Groundwater Sustainability Plan for the Marina GSA Area of the 180/400 Foot Aquifer Subbasin

City of Marina
Groundwater Sustainability Agency
Marina, CA

VOLUME II – TABLE OF CONTENTS AND INTRODUCTION
Groundwater Sustainability Plan
for the Marina GSA Area
of the 180/400 Foot Aquifer Subbasin

VOLUME II: SECTION 1.0 – ANNOTATED COMMENT LETTERS

LOCATIONS OF MPWSP BOREHOLES RELATIVE TO GSP POTENTIAL AQUITARD GAP AREAS

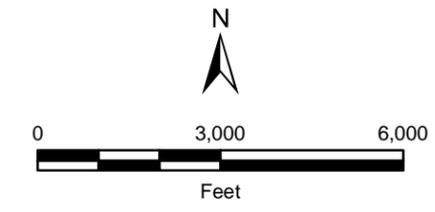
HWG Comment: *This issue of possible aquitard gaps and chloride islands was documented at locations far inland and not relevant to the Marina GSP. In addition, detailed work by MCWRA was able to assign these chloride islands to being caused by poorly constructed wells. The cited study by MCWRA did not have MPWSP monitoring well boring logs available to incorporate in their study. The locations of the MPWSP borings relative to the purported aquitard gaps (GSP Figure 3-20) is displayed in the attached **Figure 1**. MPWSP MW-8 has a major clay zone present from approximately 225 to 295 feet bgs and MW-9 has a major clay zone present from approximately 225 to 350 feet bgs (aquitard intervals in other boreholes include: MW-1: 210-275; MW-3: 215-285; MW-4: 260-300; MW-5: 305-395 (higher ground elevation); and MW-7: 225-270).*

LOCATIONS OF MPWSP BOREHOLES RELATIVE TO GSP POTENTIAL AQUITARD GAP AREAS

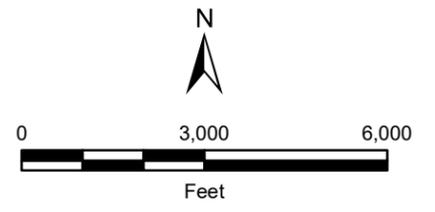
HWG Comment: *This issue of possible aquitard gaps and chloride islands was documented at locations far inland and not relevant to the Marina GSP. In addition, detailed work by MCWRA was able to assign these chloride islands to being caused by poorly constructed wells. The cited study by MCWRA did not have MPWSP monitoring well boring logs available to incorporate in their study. The locations of the MPWSP borings relative to the purported aquitard gaps (GSP Figure 3-20) is displayed in the attached **Figure 1**. MPWSP MW-8 has a major clay zone present from approximately 225 to 295 feet bgs and MW-9 has a major clay zone present from approximately 225 to 350 feet bgs (aquitard intervals in other boreholes include: MW-1: 210-275; MW-3: 215-285; MW-4: 260-300; MW-5: 305-395 (higher ground elevation); and MW-7: 225-270).*

HWG 45	Section 3.1.12, page 3-21	<p>The GSP goes into a detailed description of the surface geophysics (AEM) study conducted by Marina Coast Water District's consultants. A statement made in the GSP in this section is, "The 180/400-Foot Aquitard is discontinuous and notably absent beneath a portion of the MGSA Area and in a large area located just east of the MGSA Area. This occurs in the vicinity of an area where the aquitard was previously judged to be thin or absent by MCWRA (see Figure 3-20)."</p> <p>HWG Comment: The HWG has previously provided extensive documentation of erroneous hydrogeologic interpretations of the AEM data (HWG, November 2017, January 2018, August 2018, January 2019, March 2019, and April 2019). The HWG April 2019 document clearly demonstrates with field data that the hydrogeologic interpretation of aquitard gaps from the AEM study is invalid. Furthermore, as described above, MPWSP monitoring well borehole logs demonstrate that</p>	Please refer to Master Response 5 - Use and Interpretation of Geophysical Studies and our response to Comment HWG 30.	None
